MEMORANDUM

**SUBJECT: OP Hearing Report 3 - ZC #13-14 (McMillan)
First Stage and Consolidated PUD and Related Map Amendment
Parcel 1**

Figure 3 - Northern Sector - Parcel 1

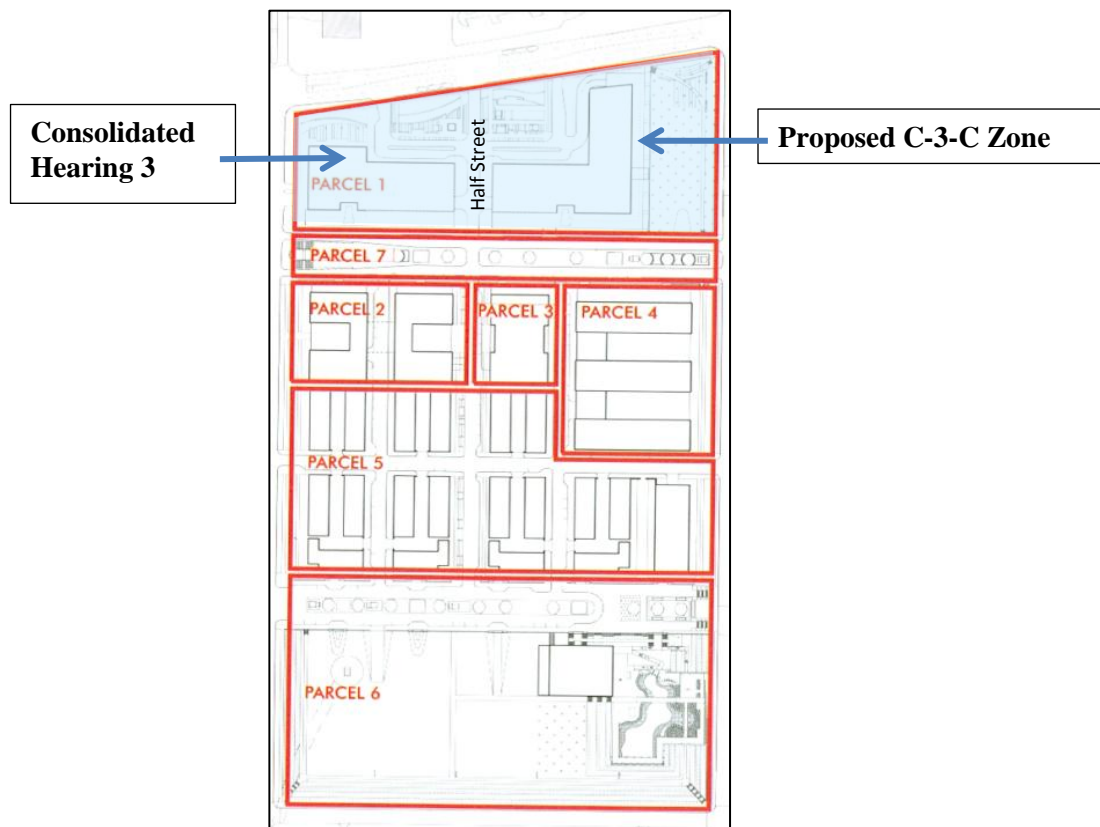
OP has advised the applicant to provide additional details regarding the nature of the healing garden sandwiched between Michigan Avenue and the transit hub, clarify the request for retail flexibility, and address the Department of Transportation (DDOT) issues such as the dispersion of traffic through the site.

Parcel 1 would include significant open spaces including medical healing gardens along Michigan Avenue. This terraced area would be approximately 10 feet below Michigan Avenue and would include the medical healing gardens, a Shade garden and a Ginkgo Grove. The Olmsted Walk would also be integrated into this open space, garden area, intended to provide a relaxing, serene space for patients, visitors and employees of the building. The applicant should further address how the healing garden

located between the transit hub and Michigan Avenue would be designed to provide a serene, reflective area.
